Ikes at Cambria
8001 28th Avenue South
PL201900209

CAMBRIA RESTAURANT

PRICING SET, 08-27-19

1 LANDSCAPE PLAN
A1.4 SCALE: 1" = 20'-0"

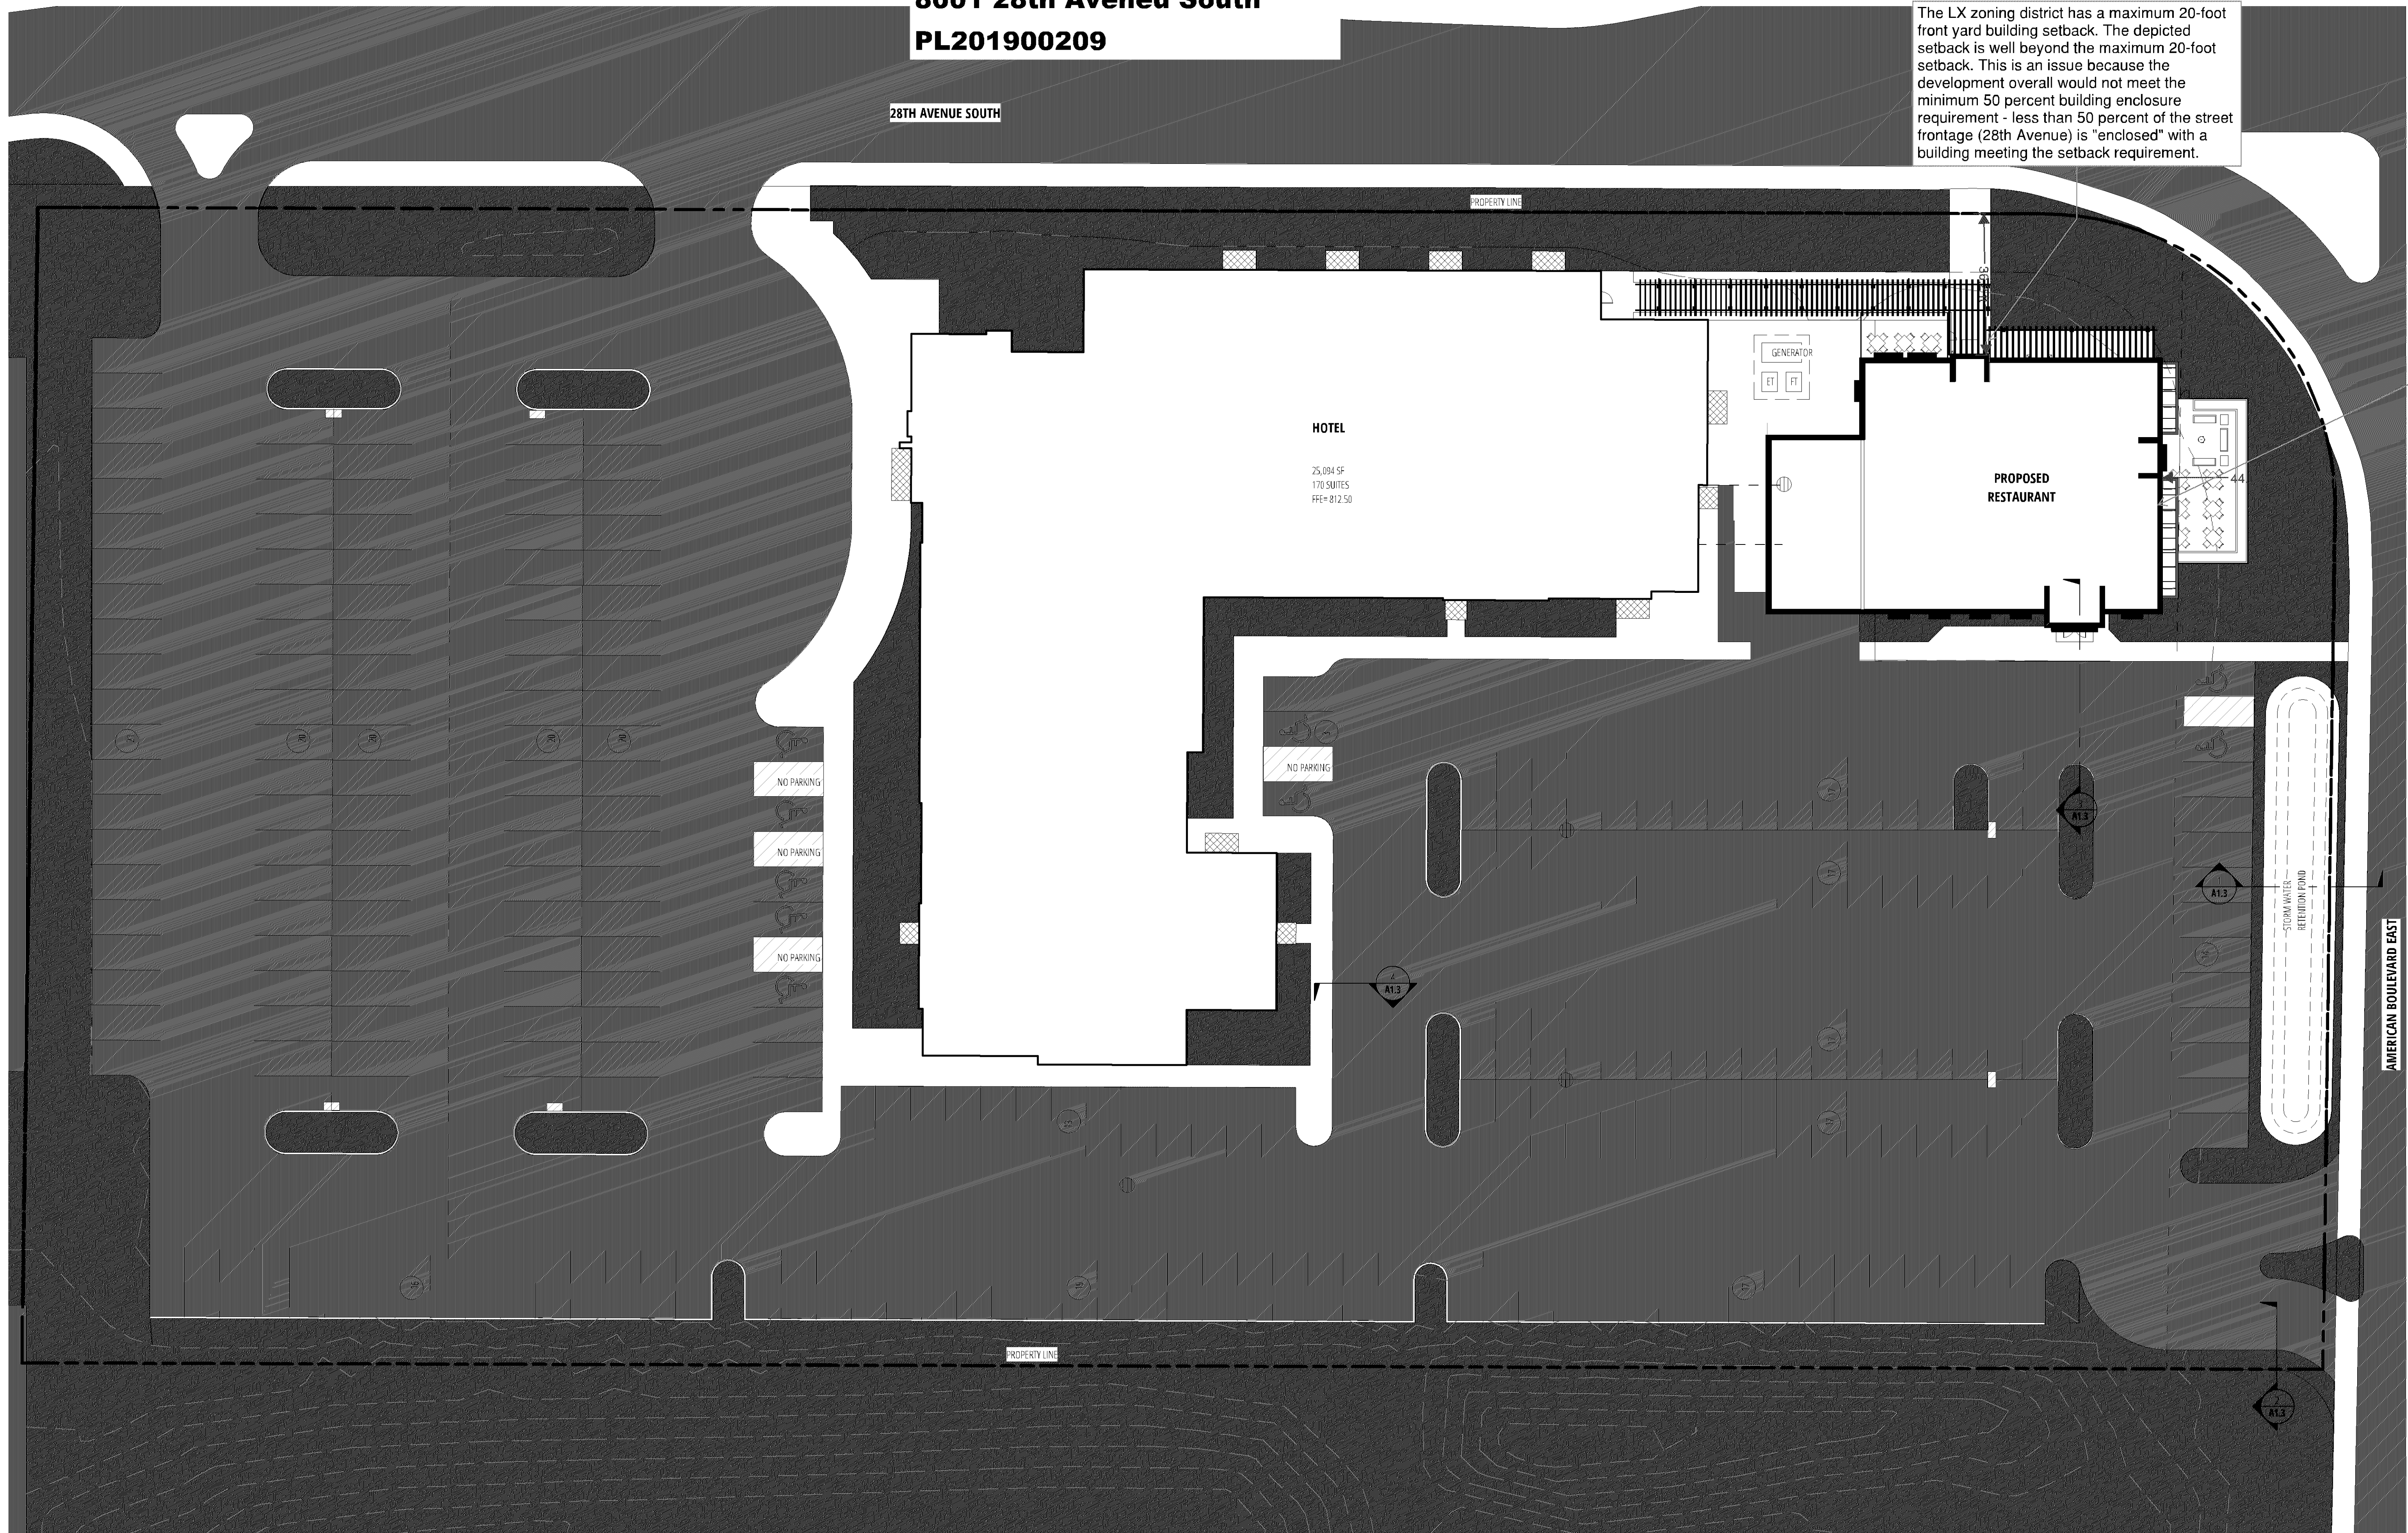
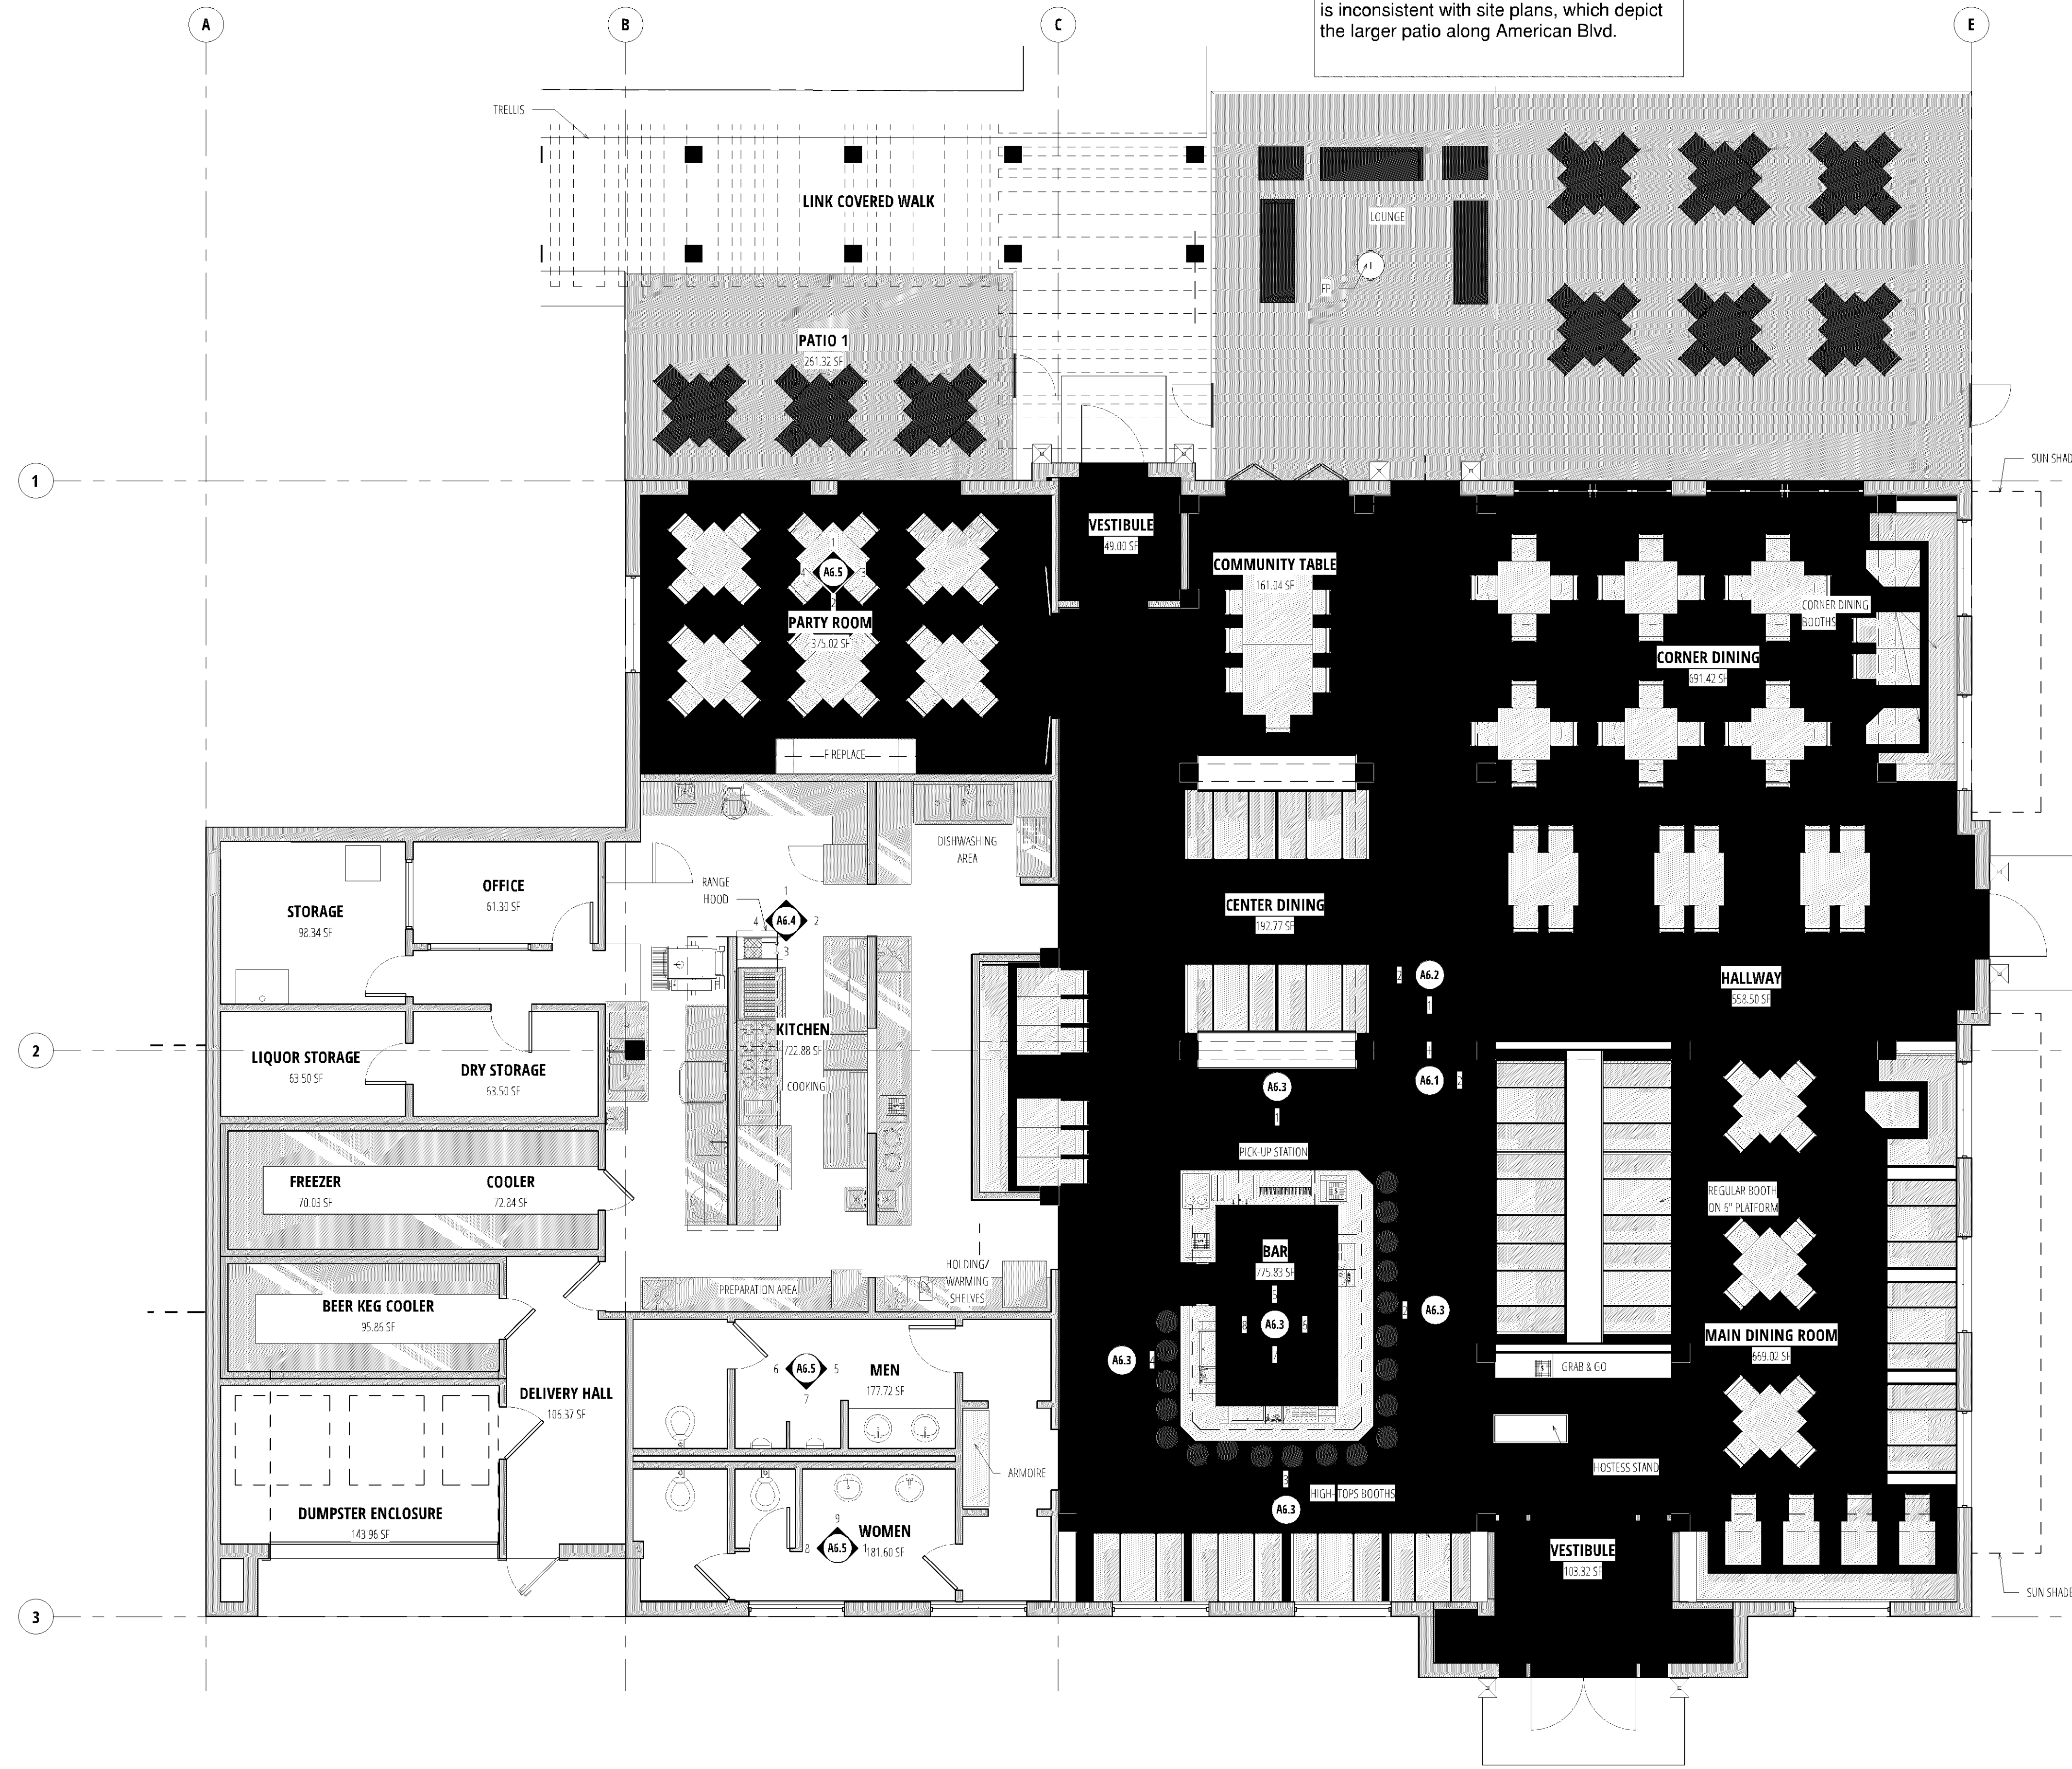
The LX zoning district has a maximum 20-foot front yard building setback. The depicted setback is well beyond the maximum 20-foot setback. This is an issue because the development overall would not meet the minimum 50 percent building enclosure requirement - less than 50 percent of the street frontage (28th Avenue) is "enclosed" with a building meeting the setback requirement.

The American Blvd. frontage does not meet the minimum 30 percent building enclosure requirement.
